LOTUS SERVICE BULLETIN

Class	III
Number	1973/2
Type	All Domestic Cars
Date	January 1973

Title: Front Registration Plates

Fig. 1

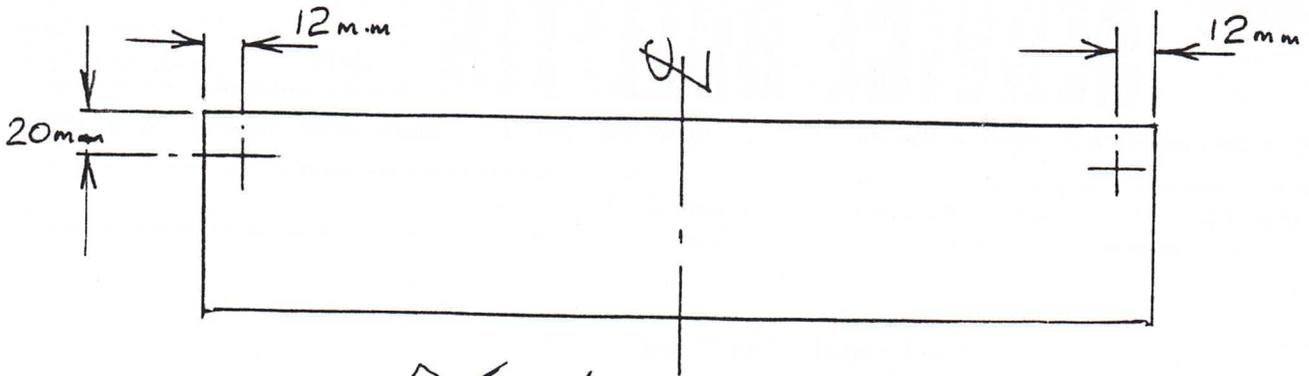
- Action:
1. Following the dimensions given in Fig. 1 (Elan and Europa), or Fig. 2 (S. 130), whichever is appropriate, drill holes in the body to accommodate the fixings for the plates.
 2. Mount brackets to body as shown in Figures. Mount plates to brackets.
 3. All holes are of 5mm. diameter

Fig. 2

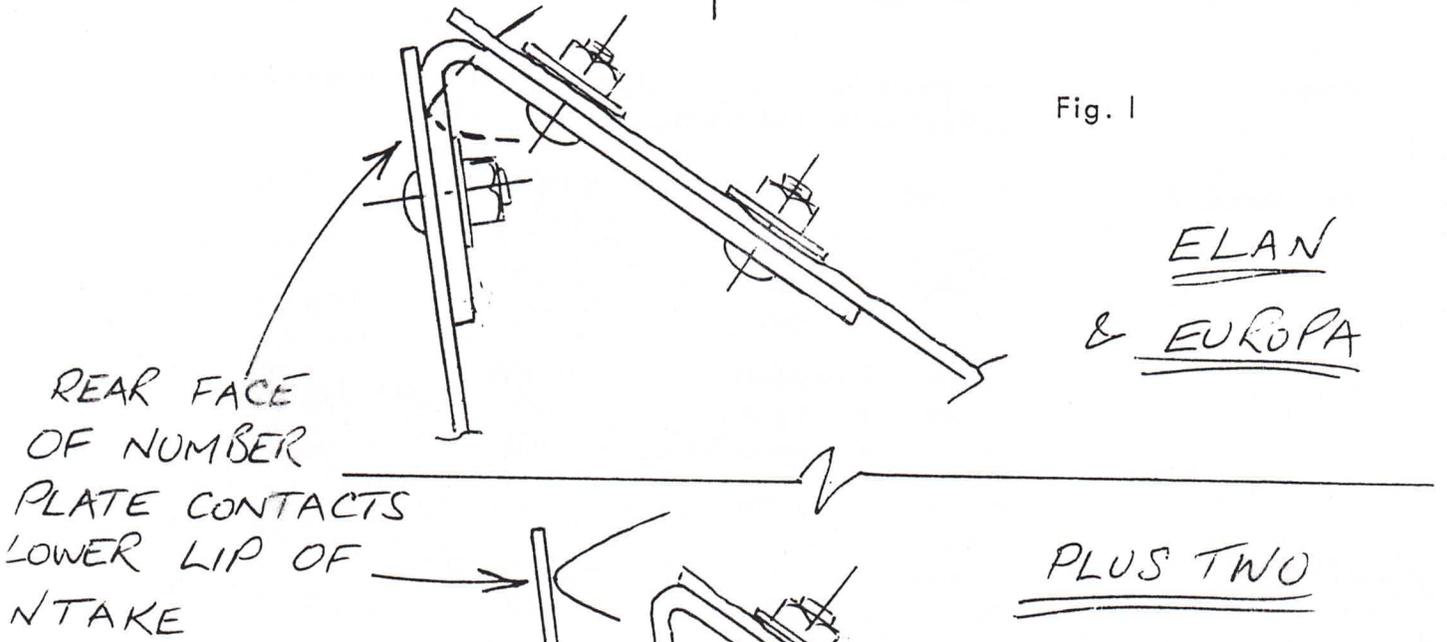
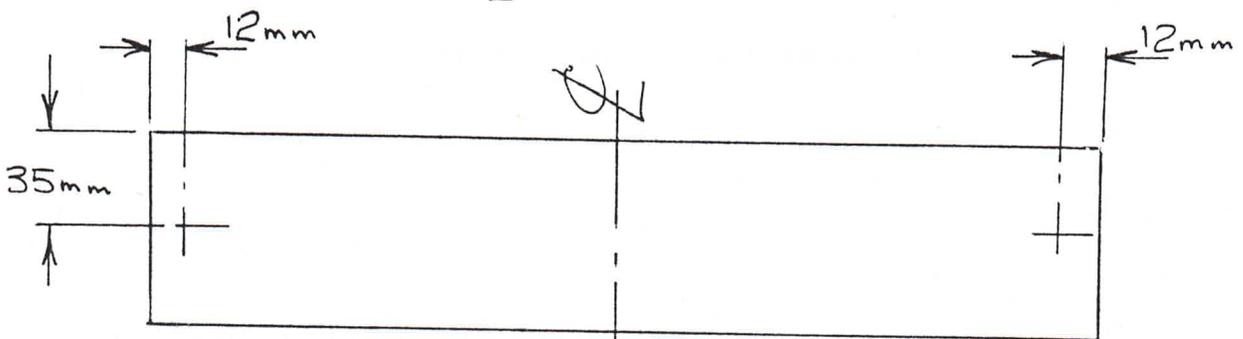
The above dimensions are to the outer edges of a standard plate (mandatory size + 1/4 in. margin all round). If a different margin is used, dimensions should be adjusted accordingly.
